**IN THE MATTER OF AN APPLICATION TO
AN BORD PLEANALA**

**For Approval of the Railway (Metrolink – Estuary to Charlemont via
Dublin Airport) Order [2022]**

ABP-314724-22

Schedule of Errata

1.2.2 R132 Diversion at Chainage Phase 1 and Phase 2

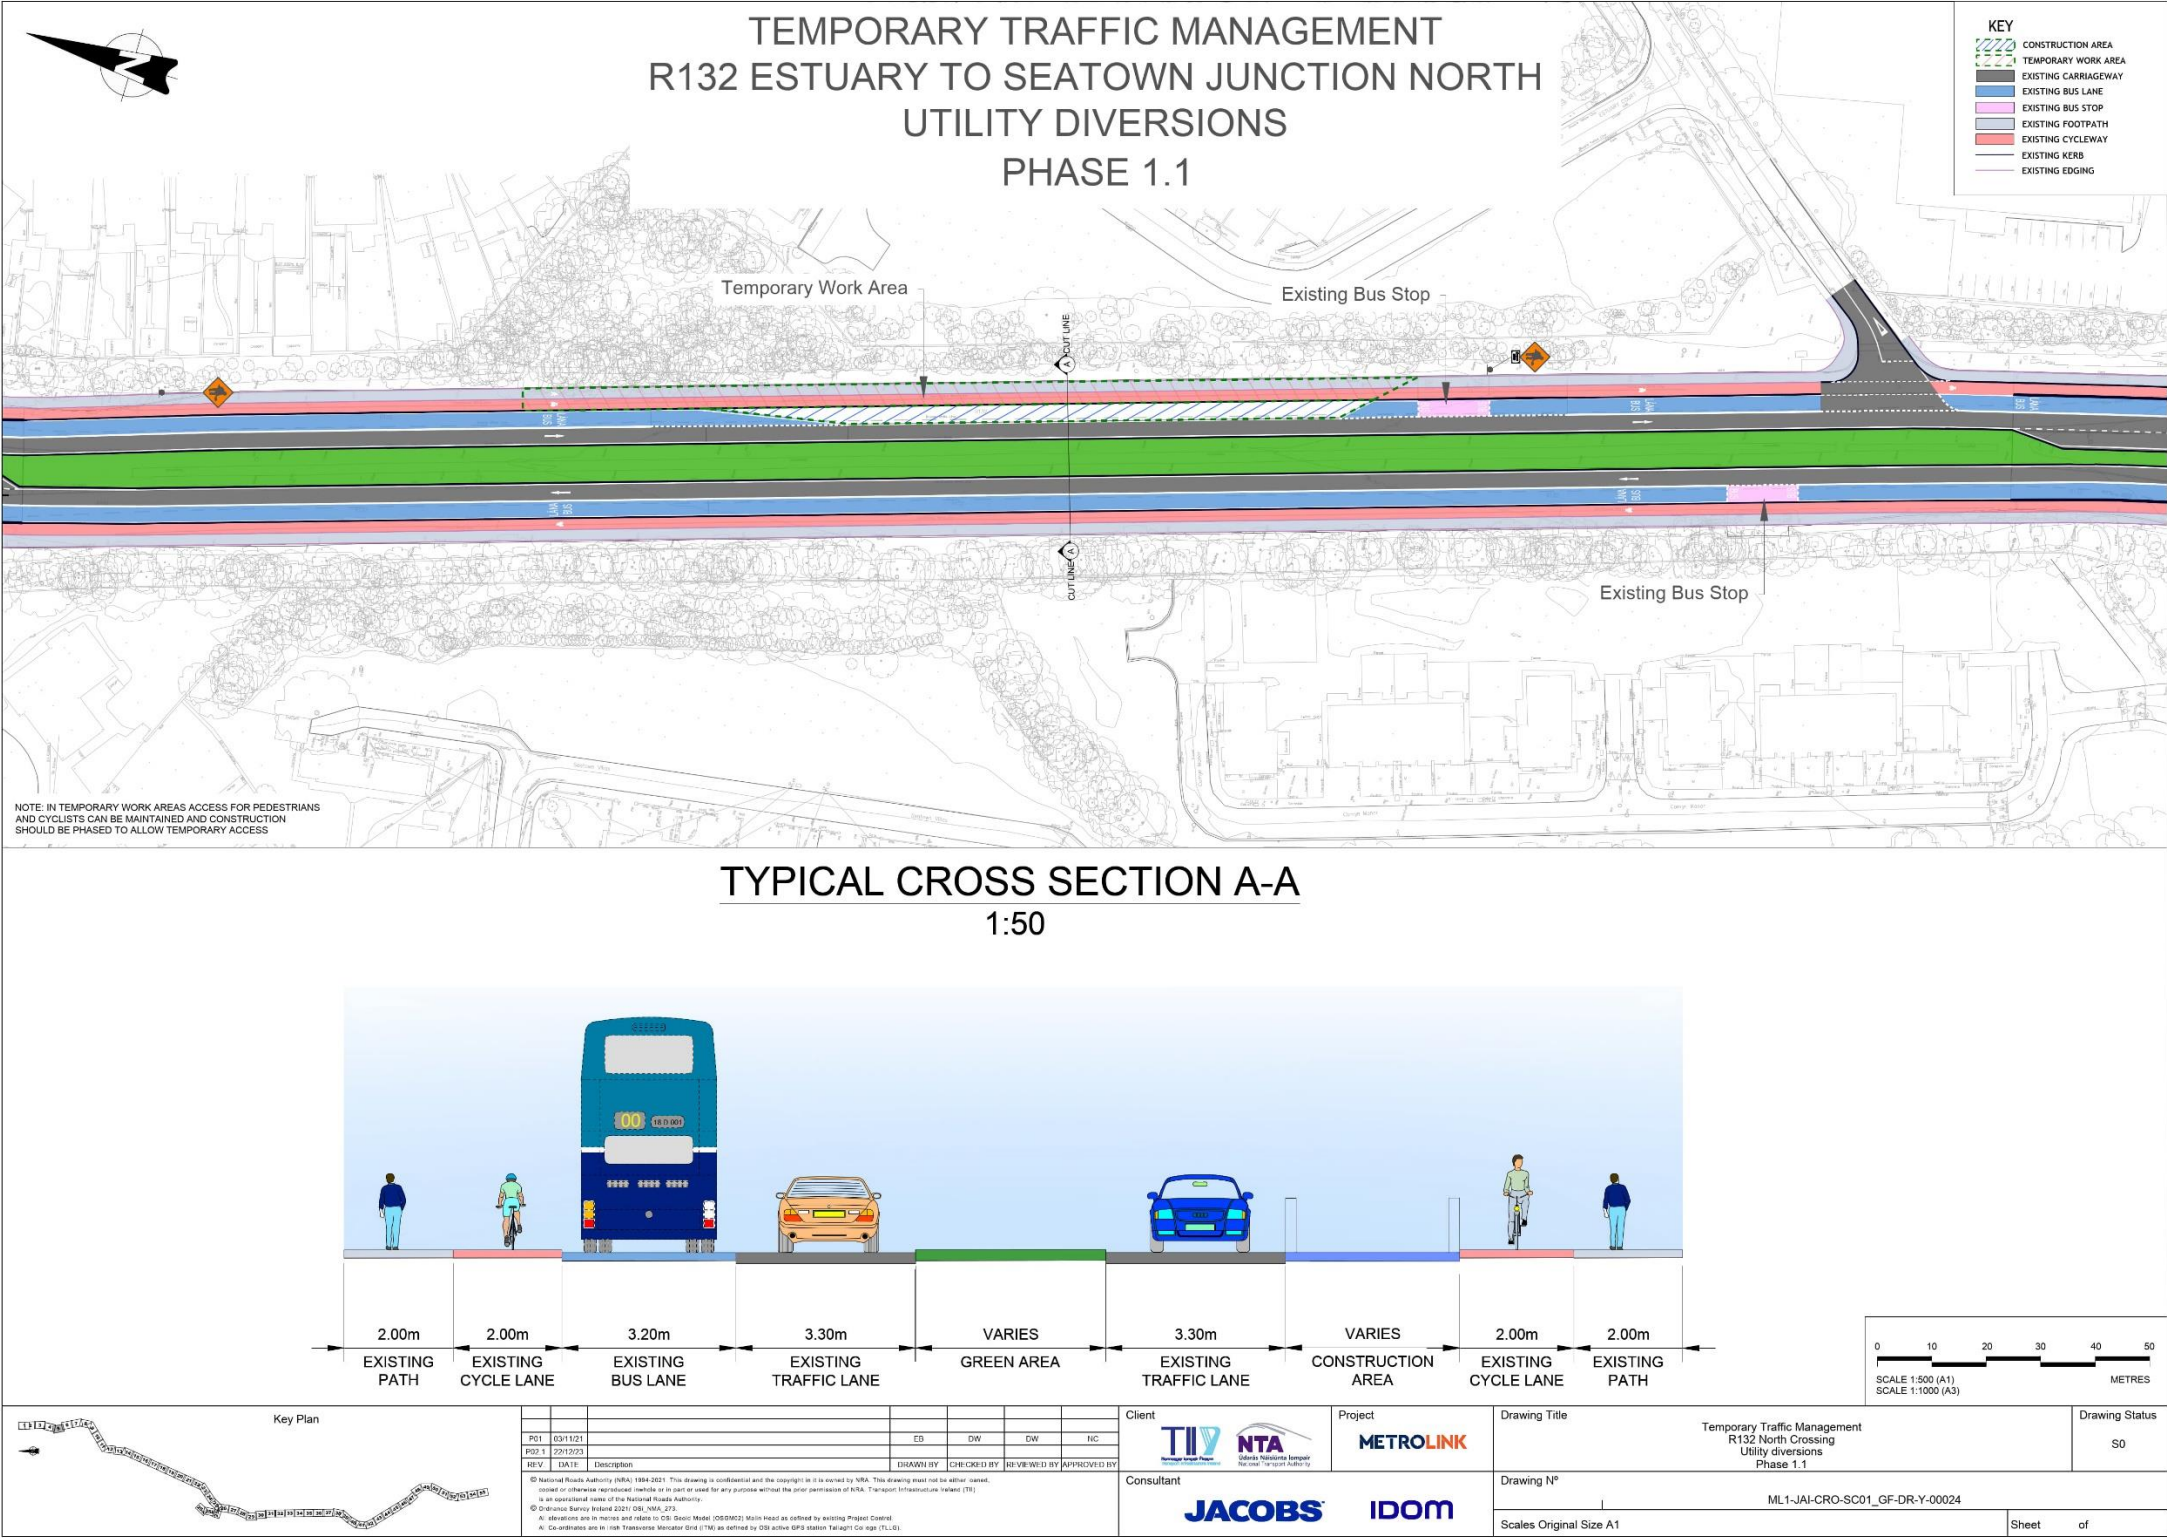
3.	EIAR Appendix A9.5 Scheme Traffic Management Plan	5.2.5.2, 5.2.6.3.2, 5.2.5.2	379; 387; 388; 389; 470; 471	Six TTM drawings show roundabout scenario on the R132 during the northern ‘cross-over’: <ul style="list-style-type: none">• ML1-JAI-CRO-SC01_GF-DR-Y-00023 - R132 North Crossing Utilities• ML1-JAI-CRO-MS02_GF-DR-Y-00003 - R132 Diversion at Chainage Ph1• ML1-JAI-CRO-MS02_GF-DR-Y-00002 - R132 Diversion at Chainage Ph2• ML1-JAI-CRO-SC01_GF-DR-Y-00024 - R132 Estuary to Seatown Junction North Utility Diversions Ph1.1	Drawings updated to show signalised scenario with R132 Connectivity Study in place, and updated associated impacts on traffic. Please refer to Appendix 1: R132 North Crossing Impacts

The temporary traffic management for R132 crossing (North), is split into two phases. Phase 1 shows the changes to allow for construction on the western section of the road. For Phase 2 the alignment switches to allow for construction on the eastern section of the road. Both phases lose the central reservation and have a reduced lane capacity of a footpath, cycle lane, bus lane and general traffic lane in each direction with a total road width of 19m.

Client				Project				Drawing Title				Drawing Status	
								Temporary Traffic Management R132 North Crossing Utility diversions Phase 1.2				S0	
Consultant				Drawing N°				Scales Original Size A1				Sheet of	
				ML1-JAI-CRO-SC01_GF-DR-Y-00025

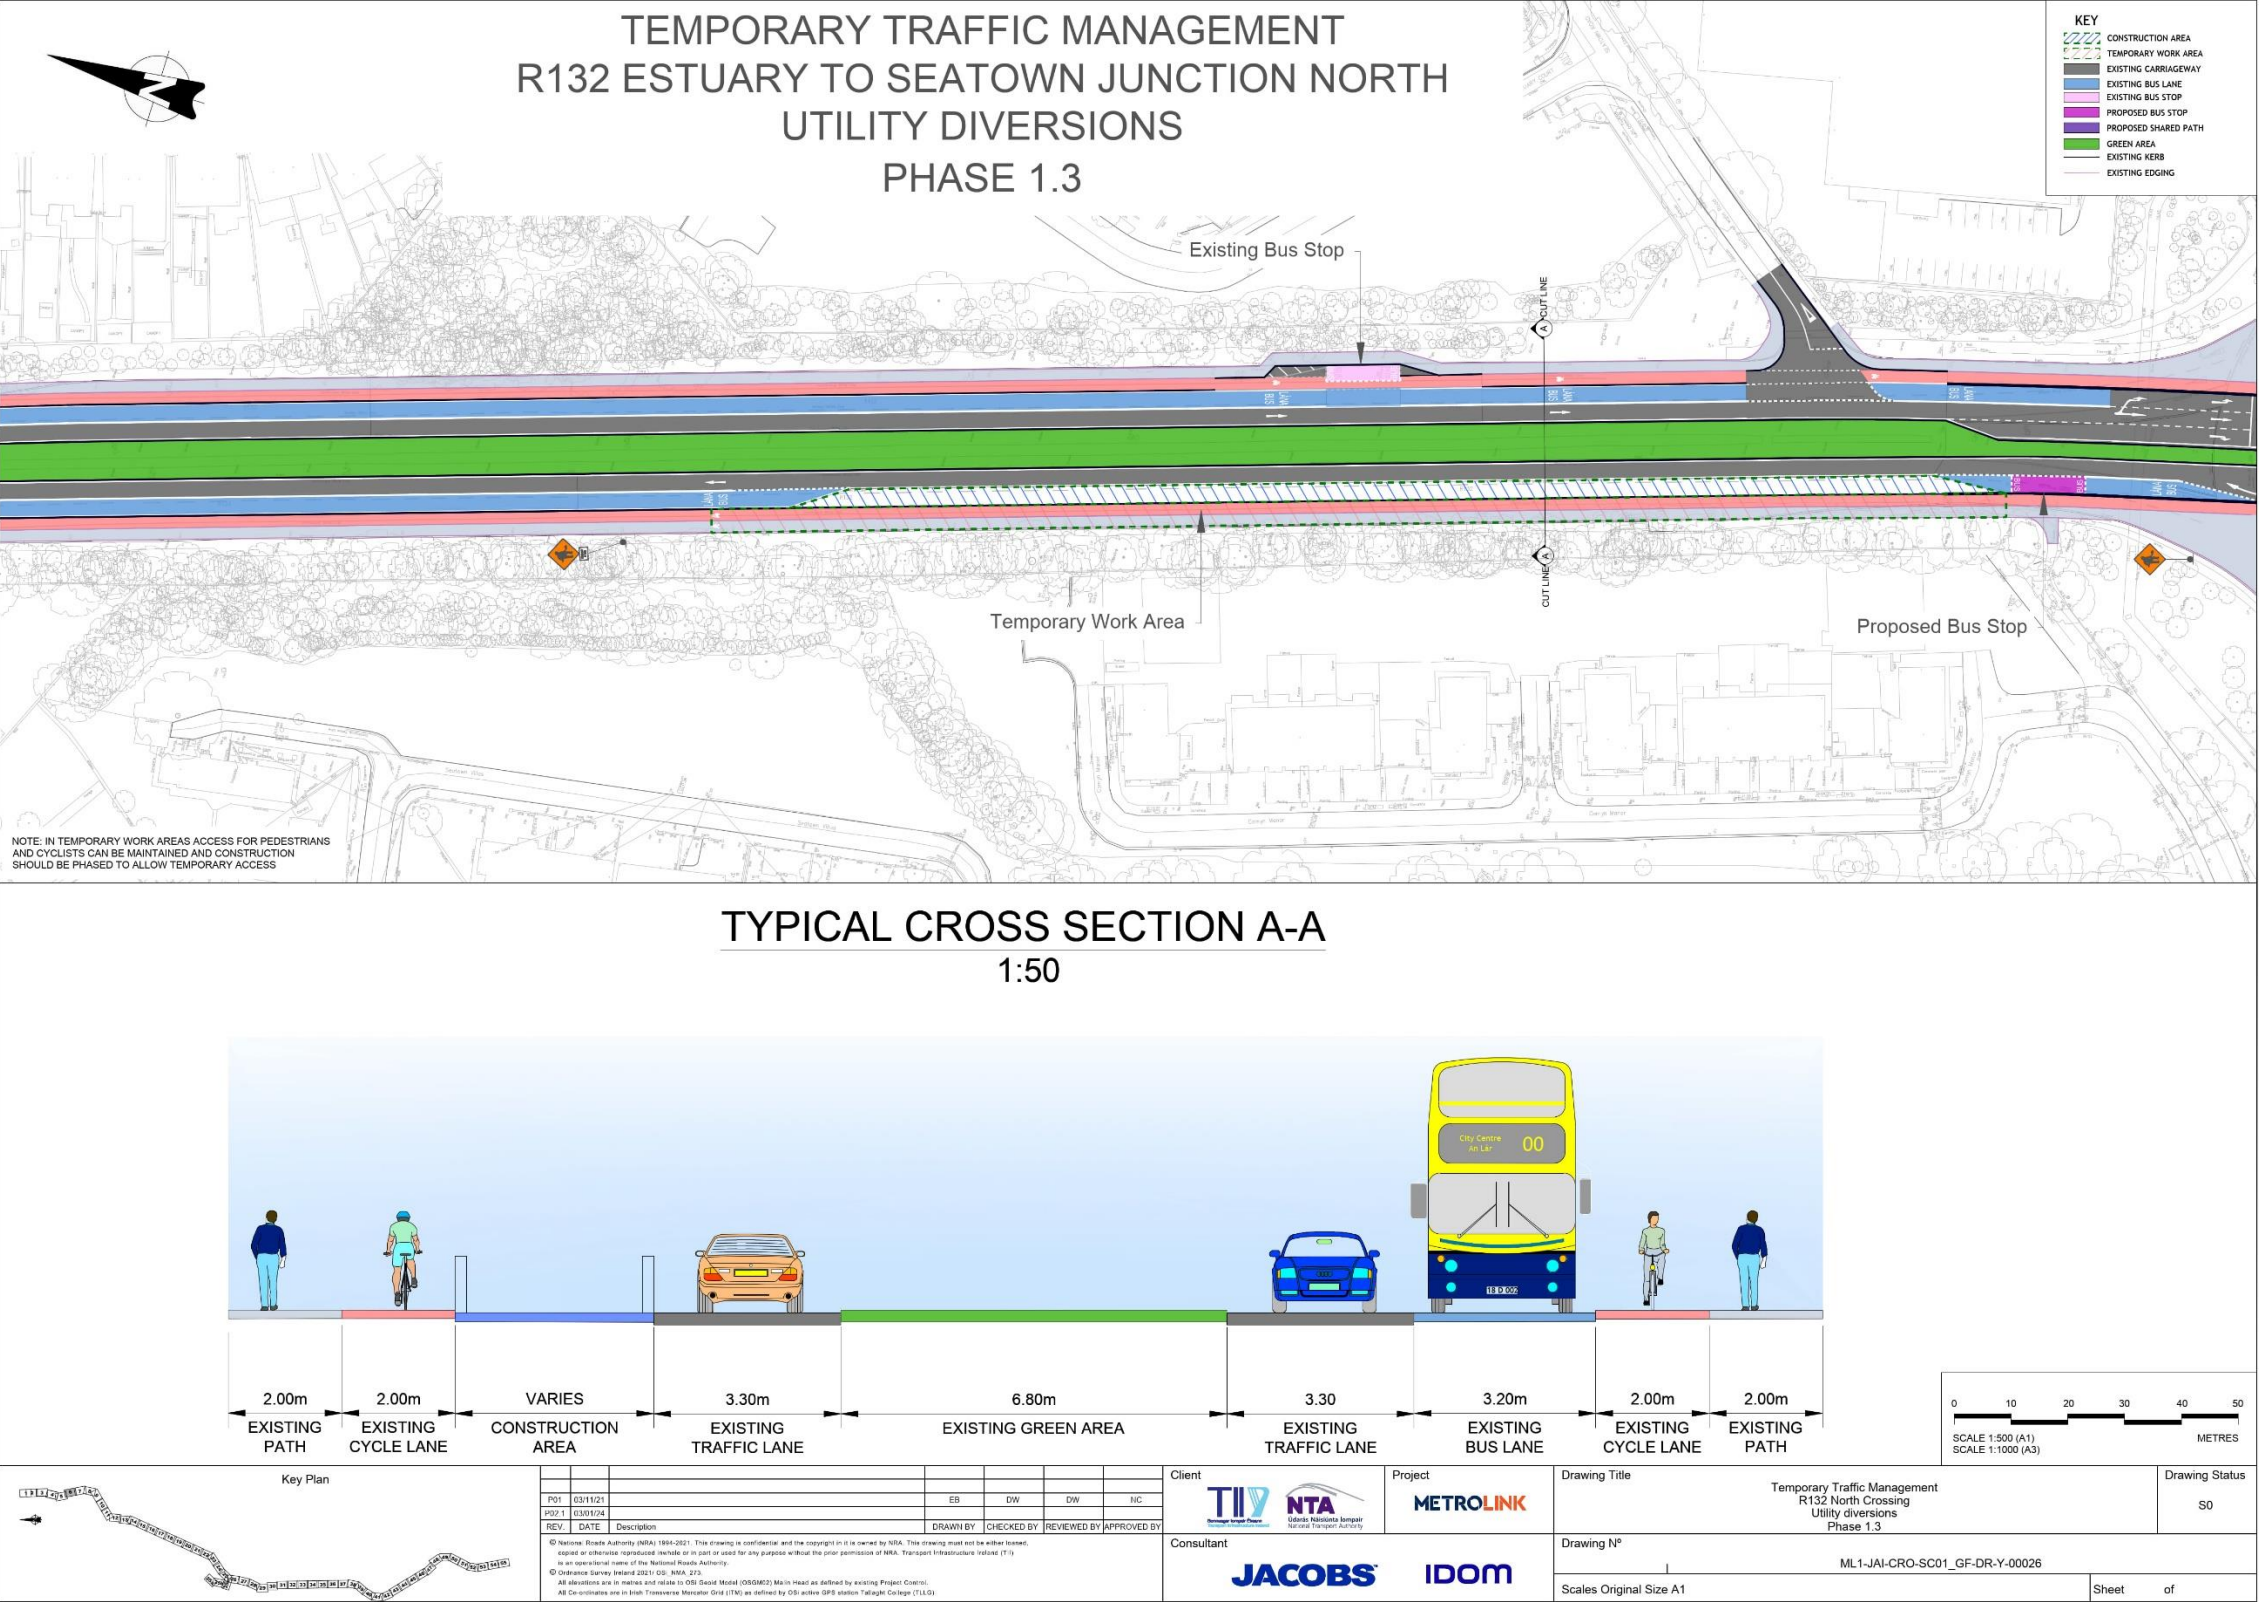
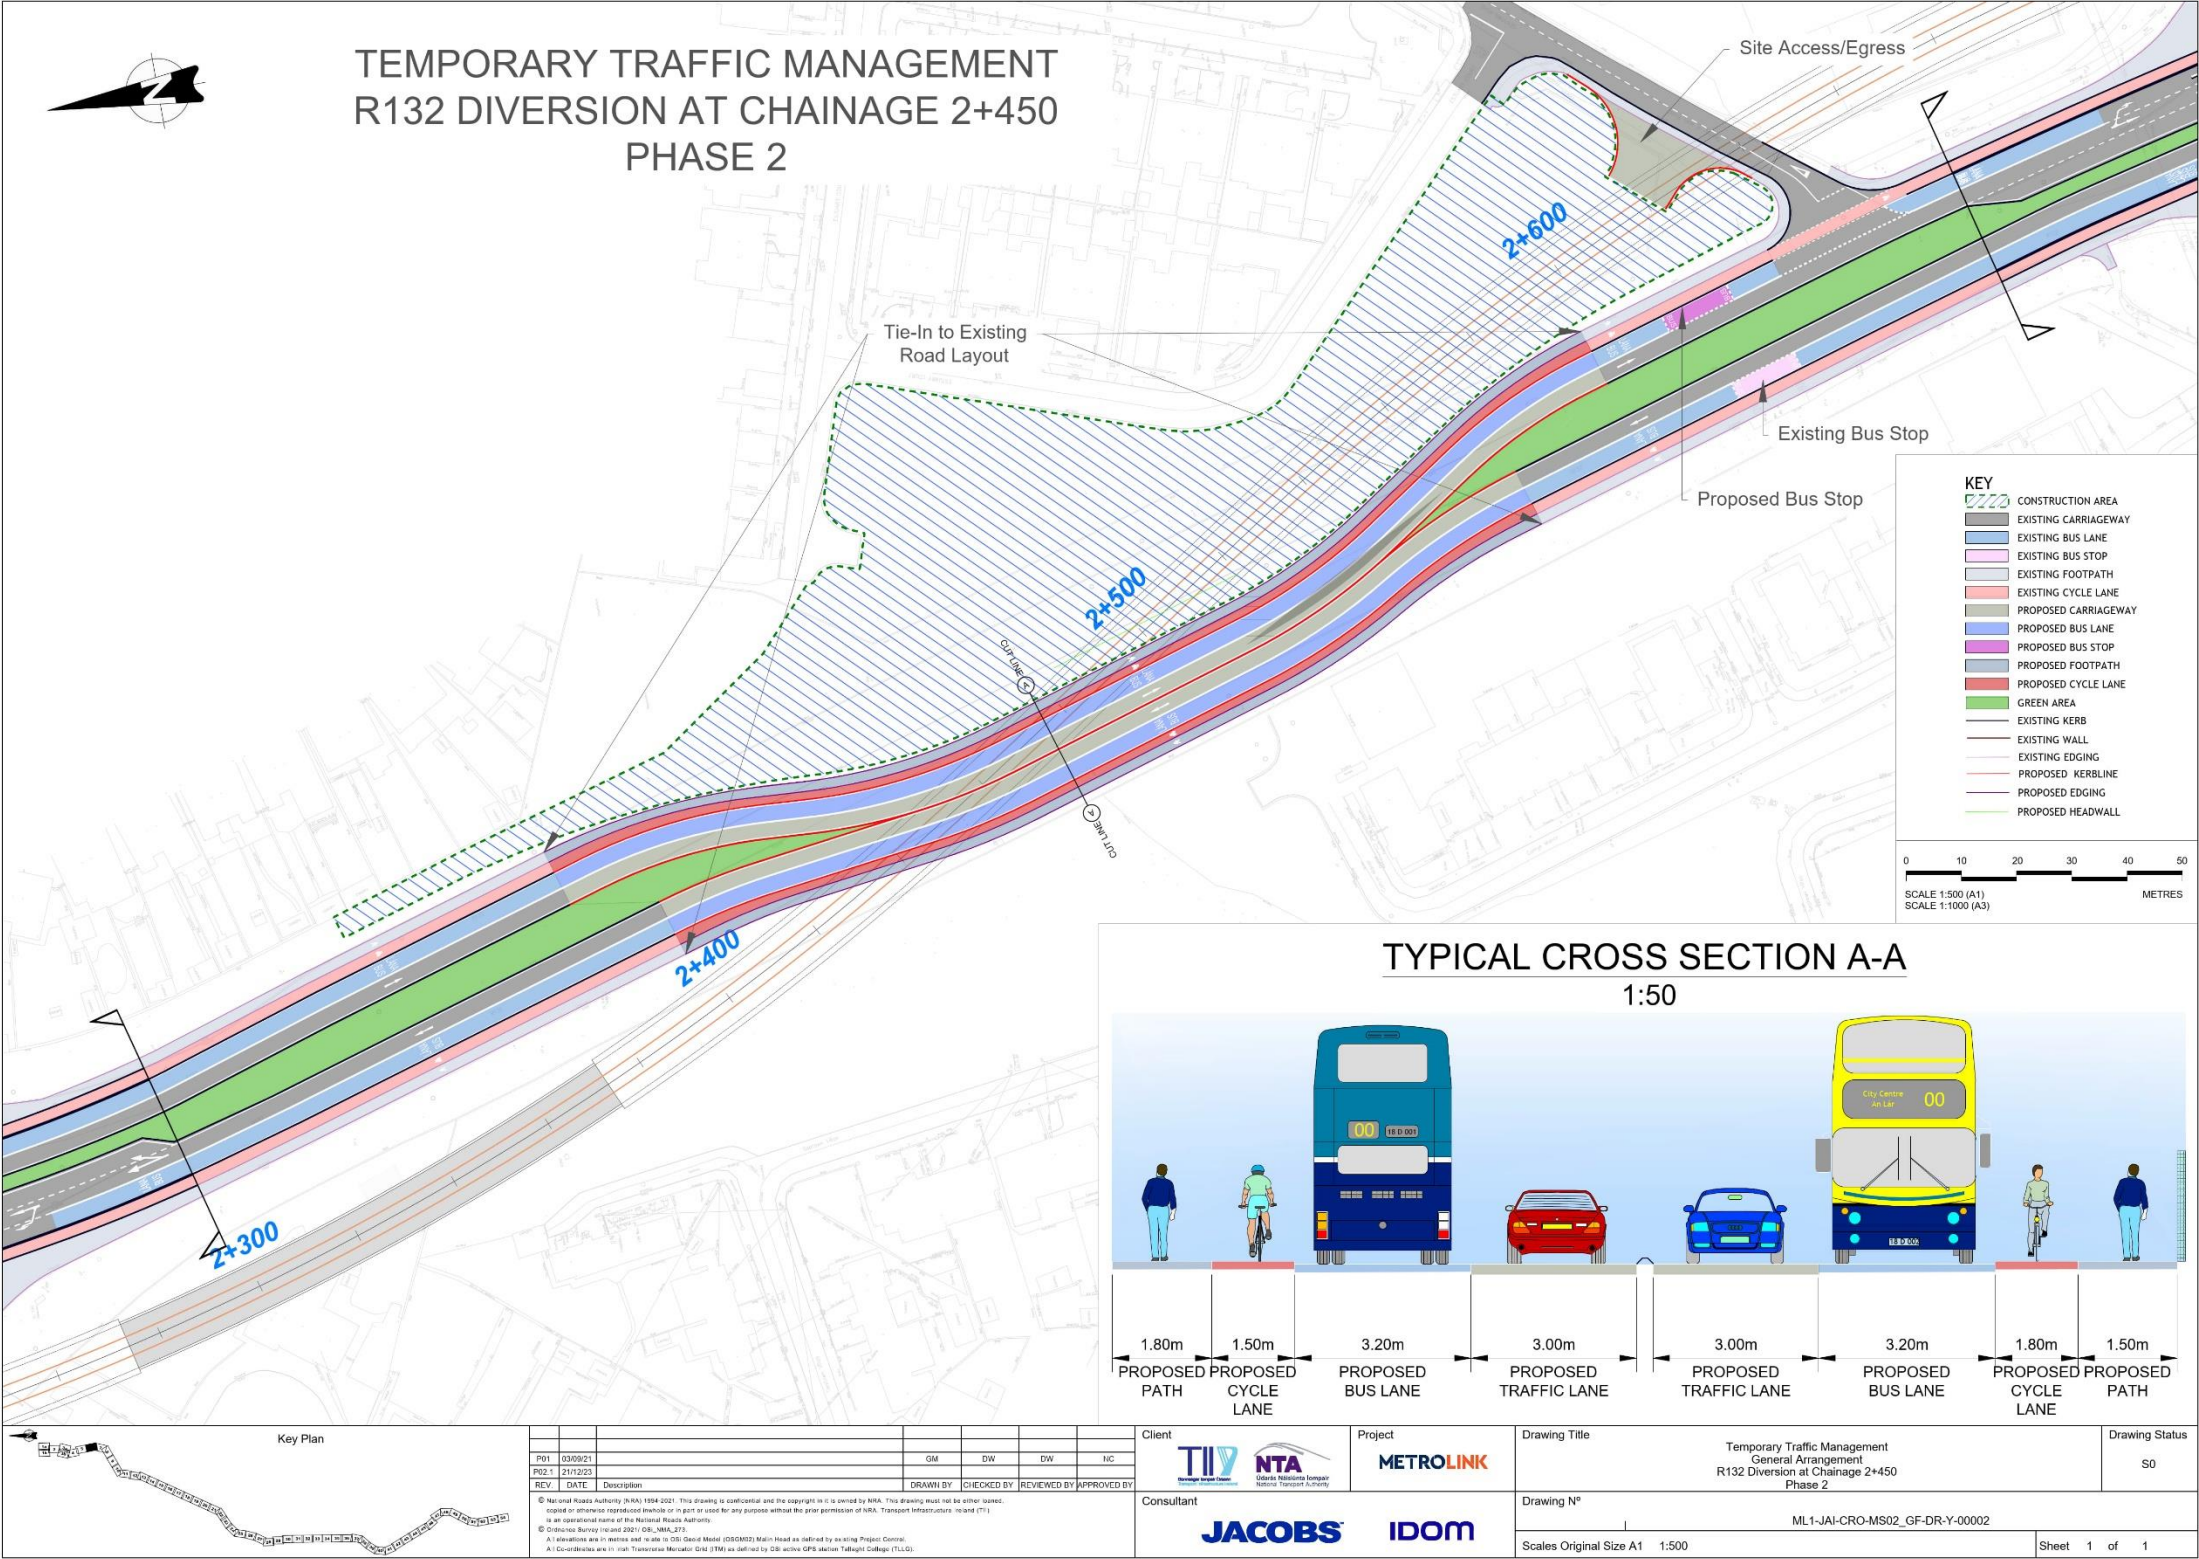
Item No.	EIAR/ NIS/ RO/ Other doc?	Section	Page	Error	Correction
				<ul style="list-style-type: none"> ML1-JAI-CRO-SC01_GF-DR-Y-00025 - R132 Estuary to Seatown Junction North Utility Diversions Ph1.2 ML1-JAI-CRO-SC01_GF-DR-Y-00026 - R132 Estuary to Seatown Junction North Utility Diversions Ph1.3

The temporary traffic management here is split into 3 phases. Phase 1 shows a pedestrian footpath, cycle lane and general traffic lane in each direction with a bus lane in the northbound direction, the southbound bus lane will be the temporary construction area for phase 1. During Phase 2, an area of 13.4m wide in the centre of the road layout, will be the construction area, allowing only one general traffic lane, one cycle lane and one pedestrian footpath in each direction. This layout will be the case for approximately 150m. During phase 3, there will be a 6.8m central reservation. In the southbound direction, there will be a lane for general traffic, a bus lane, a cycle lane, and a pedestrian footpath. Northbound, there will be one general traffic lane, a construction area of varying width along with a pedestrian footpath and dedicated cycle lane. The short-term duration of the works at this location keeps the impacts for all road users to a minimum. In general, the impacts of the temporary traffic management remain the same as originally presented in the STMP, despite slight differences in the road layouts.
